INDESIT company

Model type:
DE43EU

Commercial code:
F027209

N1045072FIG1

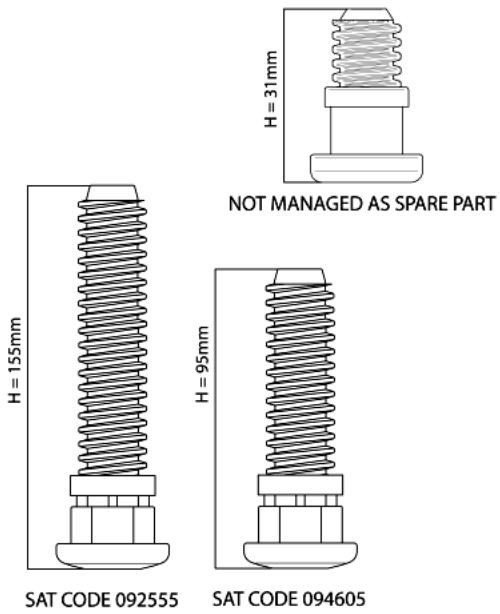
N1045072: Introduction of fixed rear foot H=31mm on free-standing models.

From serial no. 40218.0001, free-standing dishwashers affected by this modification have been equipped with new fixed rear feet (H=31mm).
The new foot replaces the adjustable one (H=155mm) Service code 092555; on the EVO3 range with TurboDry the new foot replaces the adjustable foot (H=95mm) Service code 094605.
The Spare Part Warehouse will continue to manage only 155mm and 95mm adjustable feet as they are interchangeable with the fixed 31mm foot.
The three feet are shown in illustration N1045072FIG1.

n1045058: Modification of DW turbidity kit

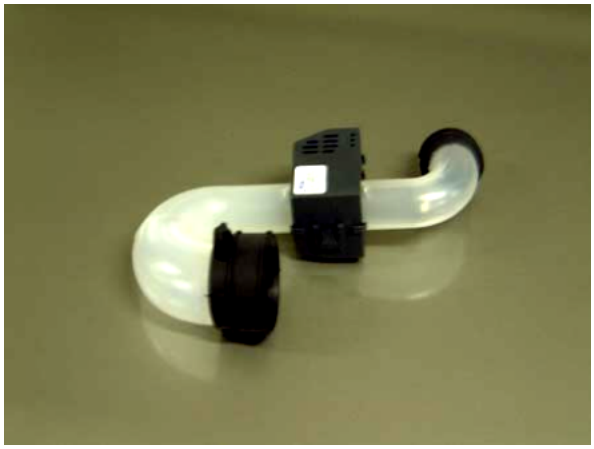
From serial no. 20830.0001, all Dishwasher models affected by this note have been fitted with the new turbidity kit Sat code 091523 replacing code 087340. The new kit has a blowing tube (a single piece that includes the two couplings and the dirt detection tube) Sat code Sat 091568 that replaces the two couplings: 078420 tube (element-turbidity sensor) and 078422 tube (turbidity sensor-pump).
The new codes are perfectly interchangeable with the old ones (087340-078420-078422) that will be managed until stocks run out.

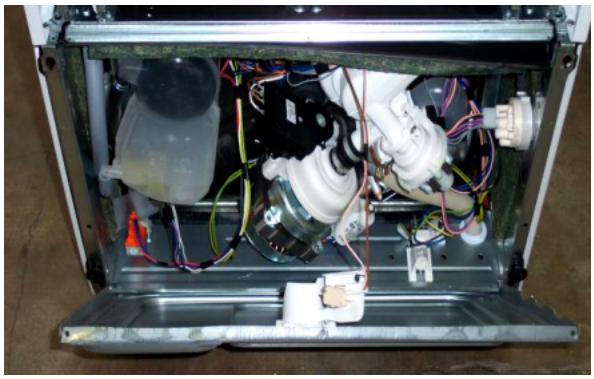
n1045062: Introduction of a new DW EVO structure

From serial number 30101.0001, all dishwasher models affected by this modification have been produced with EVO structure. These models have been equipped with NEW TRAYS AND NEW FEET (see N1045062TAB1).

Photo N1045062FIG1 illustrates the bottom of the dishwasher with EVO structure.

Regulation assembly DX/SX Sat codes 078397 and 078396 will be managed up to stock end, after that they will be replaced by new Sat codes 092821 and092820. The same is for rear foot Sat code 078385 which will be replaced by Sat code 092822.

FIG. 1
STRUTTURA
PREMODIFICA

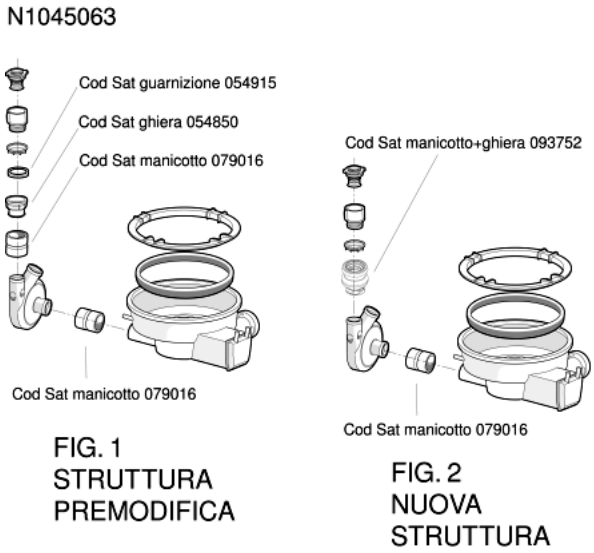
n1045063: Introduction of coupling+ring nut Sat code 093752

From serial number 30224.0001, all dishwashers affected by this modification have been equipped with the new coupling+ring nut assembly Sat code 093752, in place of coupling Sat code 079016, ring nut Sat code 054850 and gasket Sat code 054915.

Ring nut Sat code 054850 will continue to be available from the spare parts warehouse while stocks last, and coupling Sat code 079016 will continue to be stocked because it is still used for the tank-volute connection.
Picture N1045063 illustrates the premodification structure in FIG1 and the new structure in FIG2.

N1045081FIG1

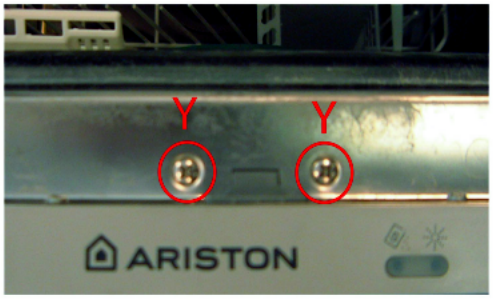
n1045081: Modification of locking units and inside doors on 45 cm dishwashers.

From serial no. 40419.0001, all 45 cm dishwashers affected by this note have been equipped with the locking unit code 094128 in place of 085357 and 087440.
Following the elimination of the two screws Y (see N1045081FIG1) used to fix the locking unit on the inside door, the locking unit and inside door were also modified, which can be mounted on premodification appliances by replacing the premodification locking unit with the new one.

Codes of modified inside doors:
091542 (EX 088175) PREMODIFICATION - 110184 NEW
091540 (EX 087151) PREMODIFICATION - 110185 NEW
